**DESIGN REVIEW BOARD AGENDA
NOTICE OF MEETING**

TITLE: <p style="text-align: center;"> DESIGN REVIEW FILE: PLAN-2019-30-APRIL-6a 80 GRAFTON STREET (PID #340265) OWNER: 1867 DEVELOPMENTS INC APPLICANT: BILL CHANDLER </p>	 CHARLOTTETOWN
MEETING DATE: April 30, 2019	Page 1 of 6
DEPARTMENT: Planning & Heritage	ATTACHMENTS: <ul style="list-style-type: none"> A. GIS Maps B. Council Resolution C. Original Design Review Submission D. Preliminary Design Reviewer Comments E. Revised Design Review Submission F. Final Design Reviewer Comments
SITE INFORMATION: Context: Vacant property in the 500 Lot Area Ward No: 1 – Queen Square Existing Land Use: Vacant Parking Lot Official Plan: Downtown Mixed-Use Neighbourhood Zoning: Downtown Mixed-Use Neighbourhood (DMUN) Zone	
PREVIOUS APPLICATIONS: Council passed a resolution on November 13, 2018 for a site specific exemption including three variances to allow the development of this application.

Re: Design Review for 80 Grafton St – 5 Storey Mixed Use .

**Re: Multi Unit Building 2 Prince Street Charlottetown, PEI
Design Review**

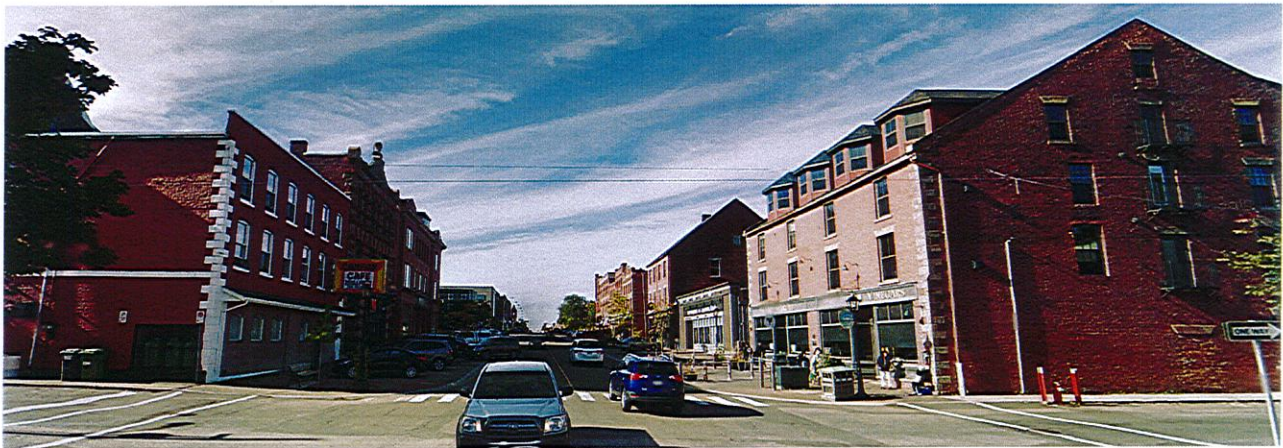
The Design Reviewer also indicates that *'the strong contrasting colour scheme of the shouldice stone and windows de-emphasizes the solidity associated with masonry construction.'*

A8
13
 Project
GRAFTON ST PROPOSAL
 Sheet Title
ELEVATION

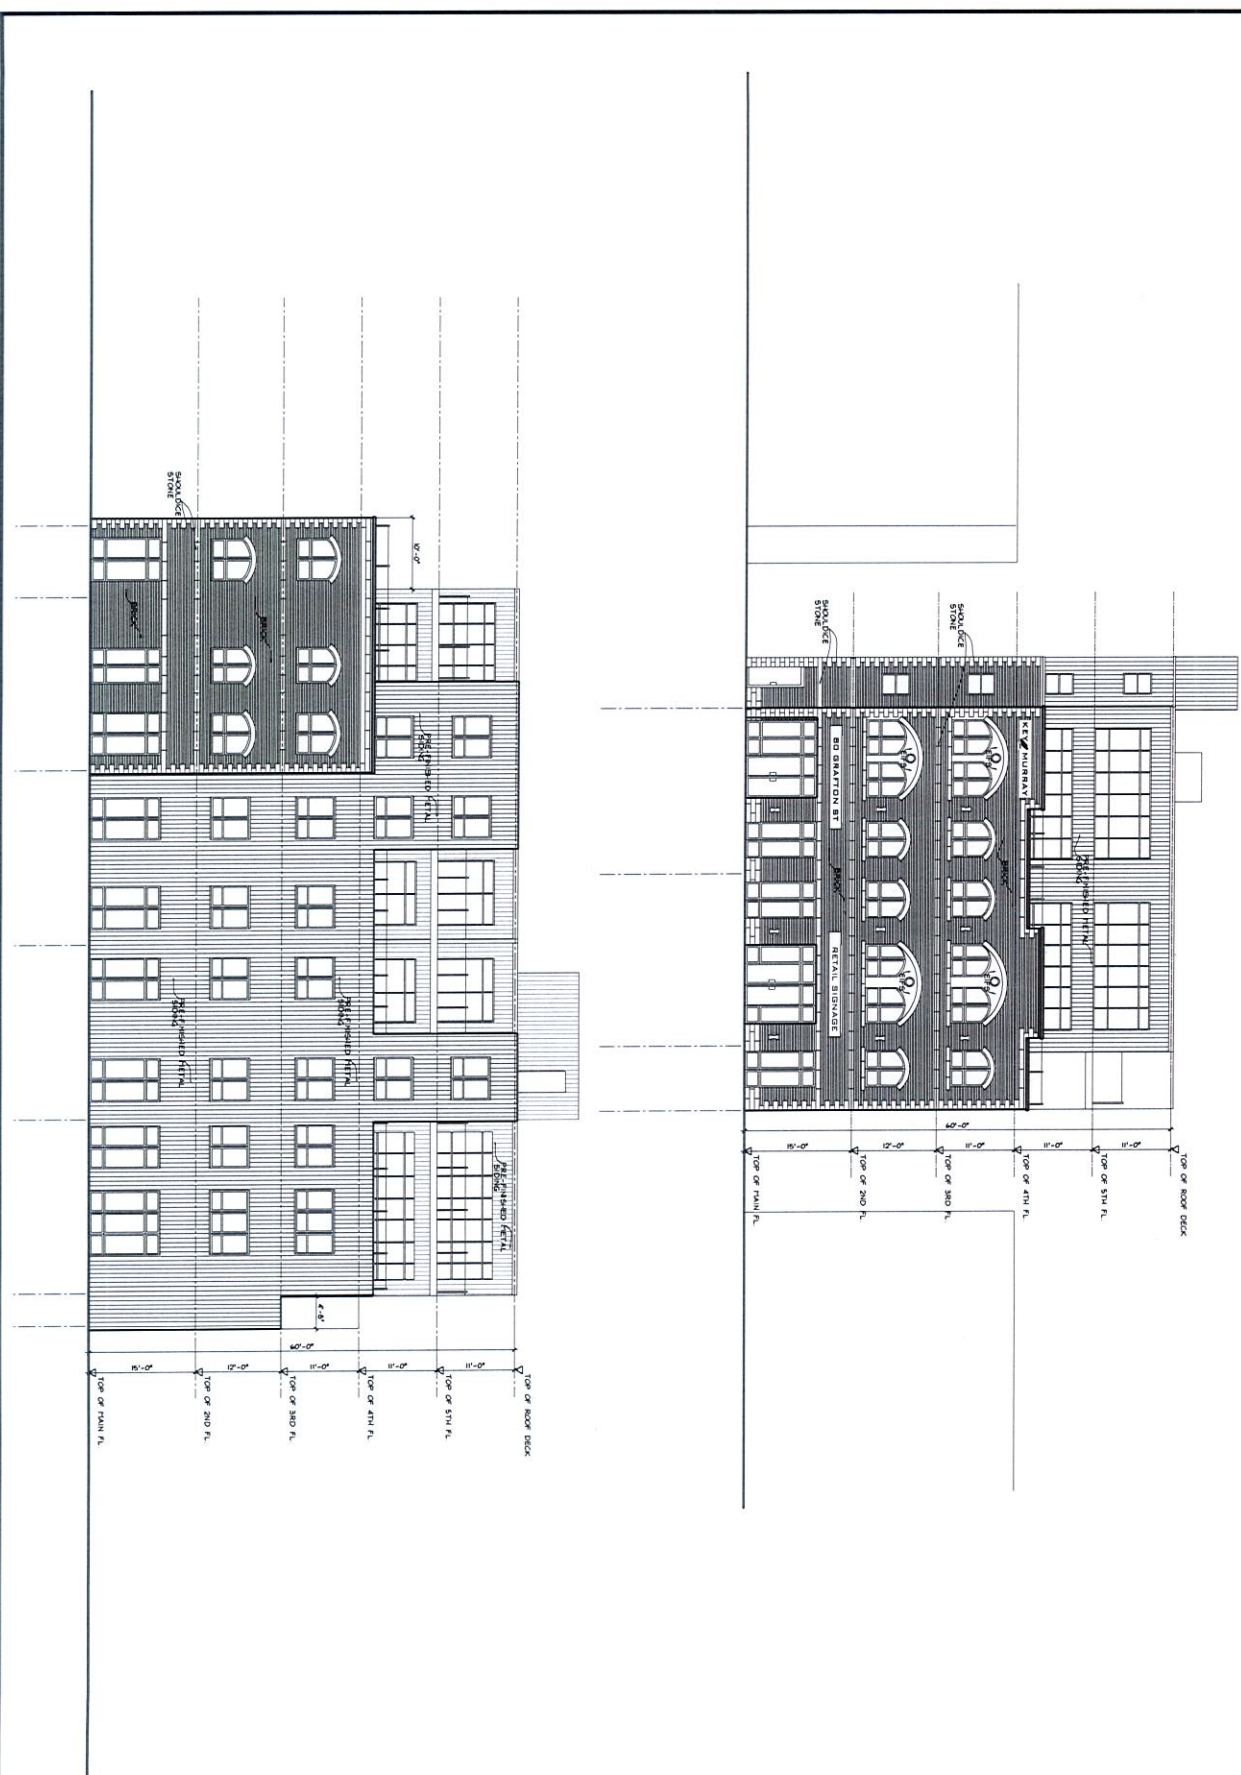
The architect has selected a route of blending the new development into the existing street context by emulating its surroundings. It is the opinion of the design reviewer that if this is the approach, then the building should be clear in its detailing supporting the tradition load bearing masonry construction. It should be relevant to the 500 Lot area and in accordance with established “orders: and details of that architectural style. **“Section 10 of guiding principals and Section 5.3.1. of the 500 Lot Standards and Guidelines discourages historic mimicry with incorrect or inappropriate detailing.”**

The strong contrasting colour scheme of the shouldice stone and windows de-emphasizes the solidity associated with masonry construction. The window proportions do not reflect load bearing masonry walls. They are too wide and not tall enough. The stucco infill between the windows, is inappropriate. Typically in paired arch-topped windows, there is the masonry opening, and then contained within, is a pair of wood mullied windows. The material and colour located in the masonry opening is consistent.

When located between two building of different heights, the taller cornice height shall prevail.	The proposed design does not meet the intent of this section.
	Maintain Heights and Proportions of the 1 st Storey	The proposed design does not meet the intent of this section.
	Reinforce the prevailing rhythm of heritage buildings – generally narrow vertical Proportion	The proposed design does not meet the intent of this Section. Both the building front width and window proportions.
		Glass Guardrails at upper decks need to be pull back from the front façade.

Section 7.3 Front façade height and width	<p>7.3.1 The primary plane of the front façade shall not appear taller than traditional Buildings on the Street, unless the adjacent Building marks an identifiable transition in Building style and/or land use.</p> <p>7.3.2 Building elements that are taller than the primary plane of the front façade shall be designed to contrast that of the lower levels in materials and/or design.</p> <p>7.3.4 For Larger wider buildings, vertical subdivisions or bays in the façade at a width consistent with the street.</p>	<p>The building primary façade is taller than both adjacent neighbours.</p> <p>The architect has made a strong change in appearance to the upper (2) Floors of the building. Steel Cladding, is proposed. However there is very little detailing presented. The design needs more refinement and detailing. There is no expression of floor plates, or cornices.</p> <p>The current design does not break the façade down into smaller subdivisions.</p>

Section 7.5 Windows	All Sections	The proportion and detailing of the windows are not well aligned with the style of the building. Arch top windows – the mainstyle on the primary façade are not continued on the step-backed portion of the street façade (A8 Elevation)
Section 7.6 Roof	All Sections	The current design meets the intent of this section.
Section 7.7	All Sections	At this level of development - The current design meets the intent of this section. – Review final location of plumbing stacks, HRV and exhaust fan locations during design development.
Section 7.9	7.9.1 A Landscaped Area shall be provided between the sidewalk and the front façade of the Building, where appropriate for a continuous streetscape.	Not Applicable
Section 7.12 Storefronts	7.12.1 – 7.12.3	The revised drawing has increased the amount of glass on the storefront. However there a lot of inconsistencies in column widths. Windows are returned at entries, but masonry is left between the windows, emphasizing the thinness of the brick veneer. Section 7.12.3 requests an identifiable transition between ground floor and upper floors. The pilot house has a clear example of material differentiation and window size changes from reference.

PROJECT TITLE
 NEW MULTIFAMILY
 2 PRINCE STREET
 EXTERIOR ELEVATION

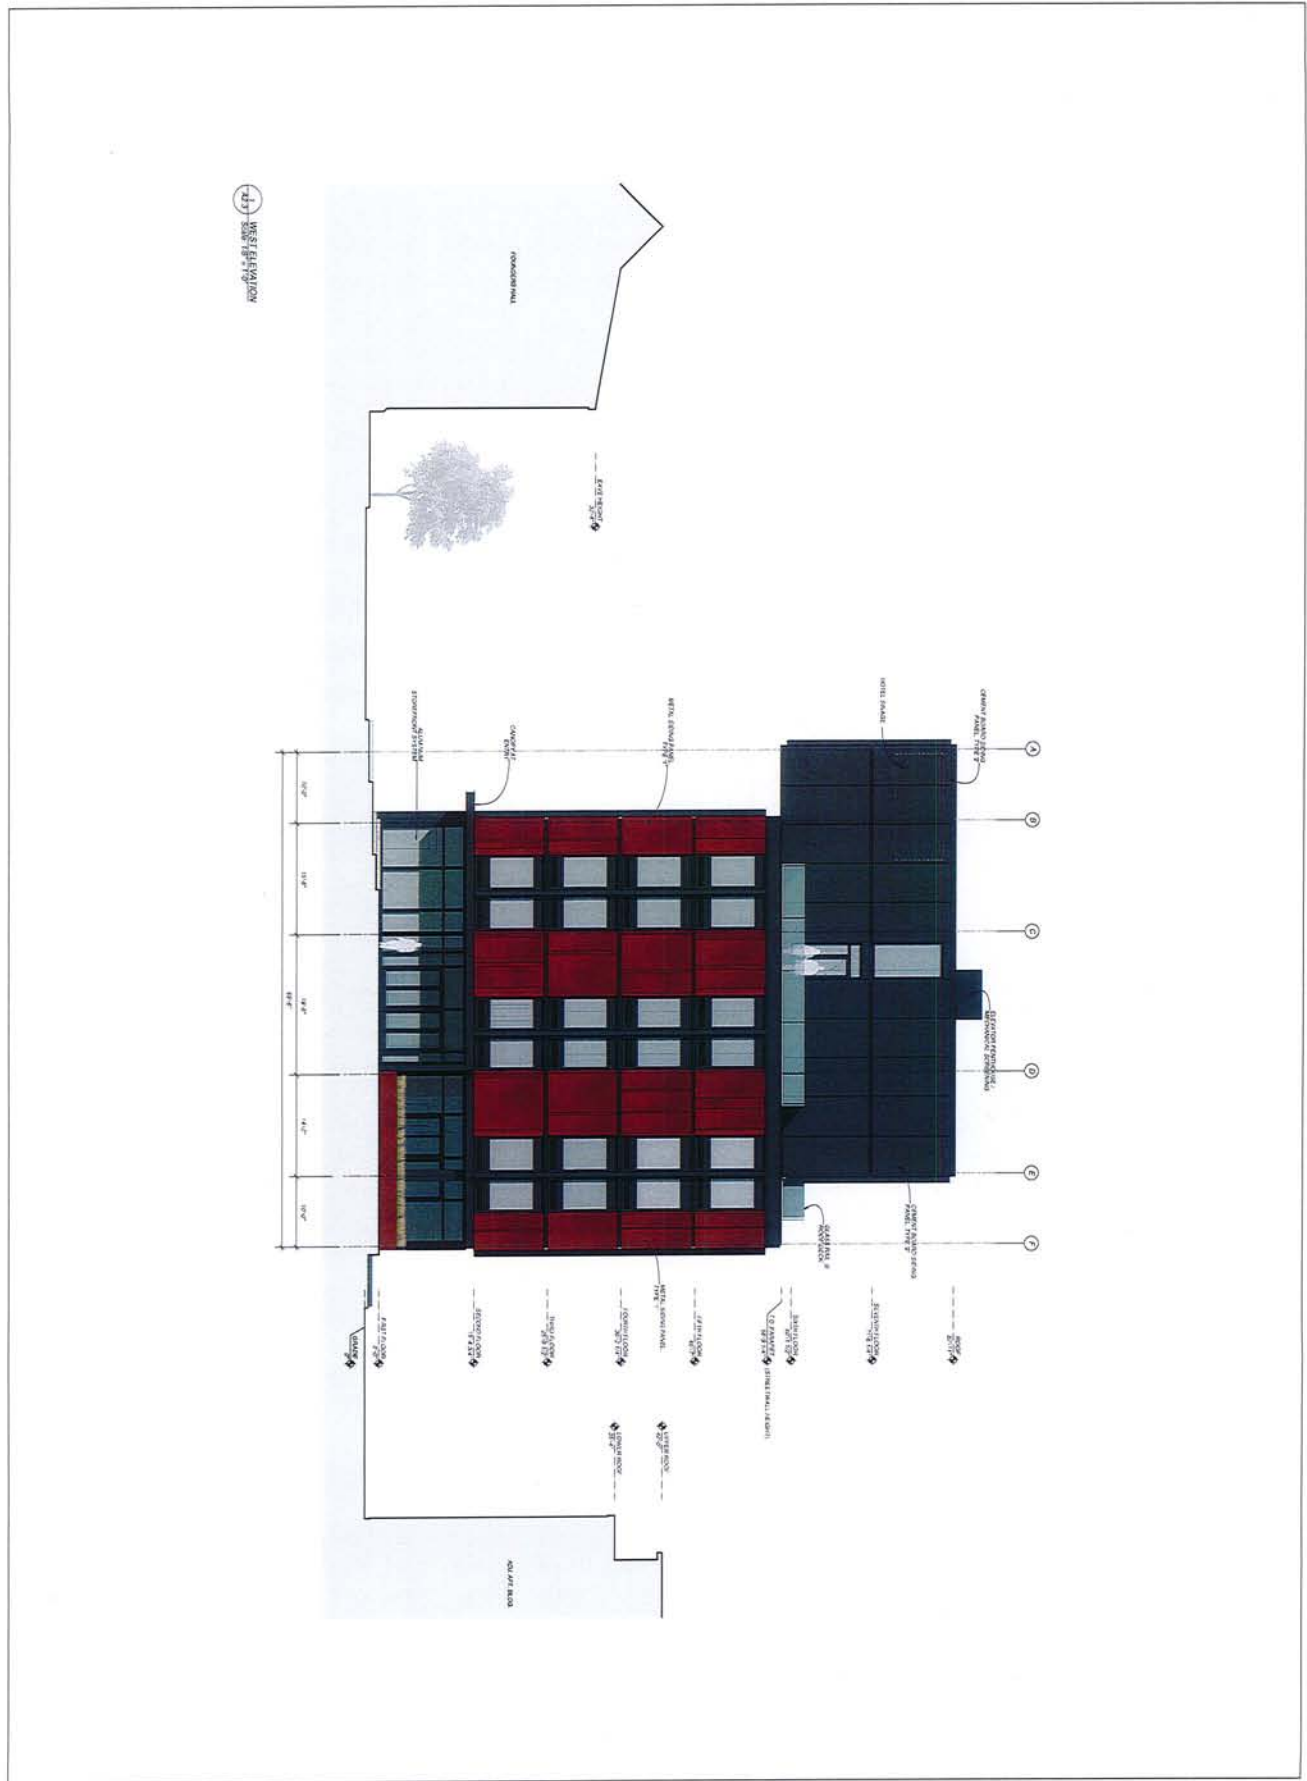
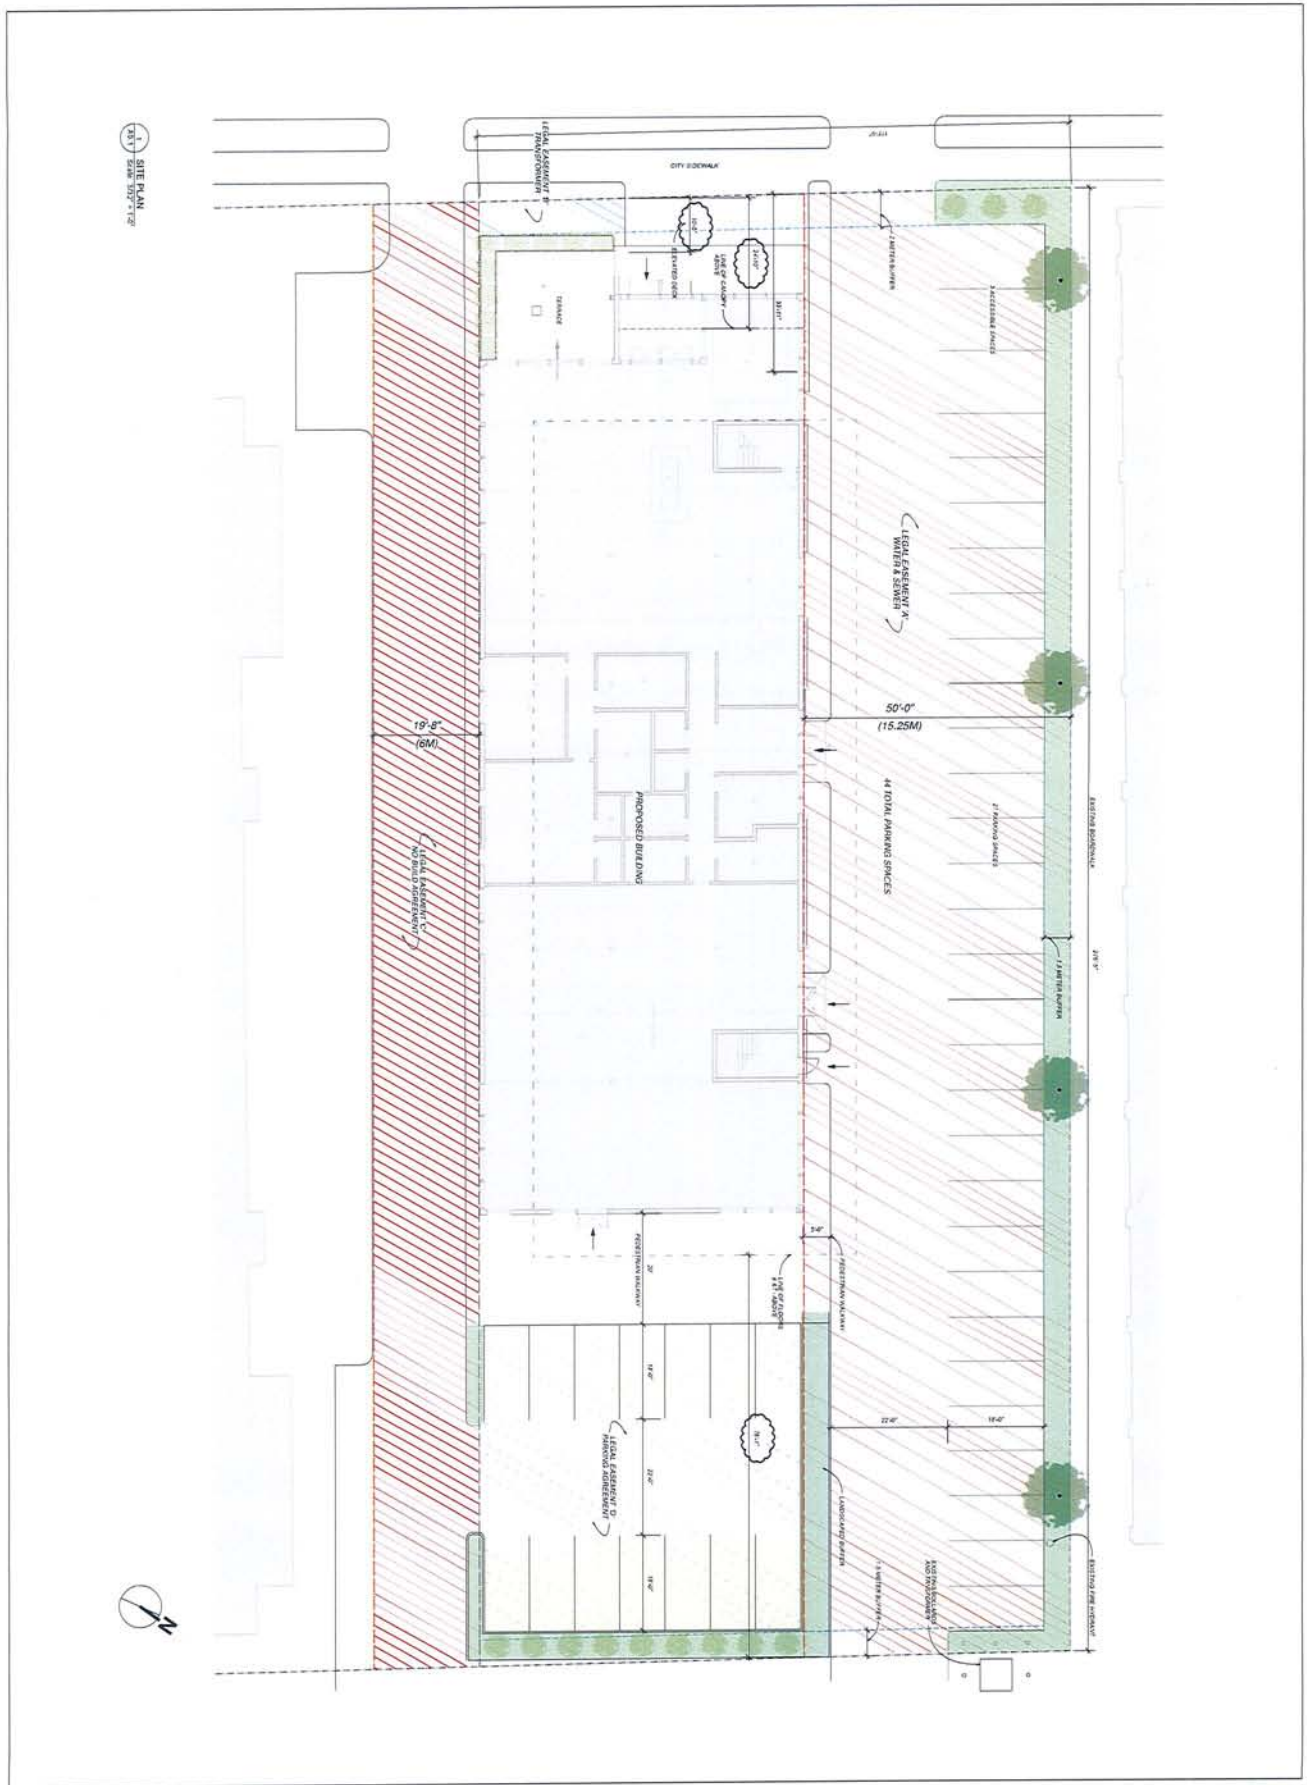
- The rhythm of the windows on all facades are at a nice scale and relate well to both neighbours.
- 7.3 While the proposed building is taller than its neighbours, with the fifth floor step back and a greater setback in front, the apparent size is diminished. Its width is in keeping with the surroundings.

- 7.4 The proposed materials are all acceptable and are true to their nature. We might suggest that at grade level the black cement board could be replaced with black brick which might better relate to both neighbours. This could include the planters as well.

- 7.5 The new facades, as mentioned above are well balanced and wrap all sides well. All windows are non-reflective and consistent with each other.
- 7.6 The expression of the roof is very clear as it cantilevers beyond one side and the rear with a strong but simple cornice at the fifth floor.
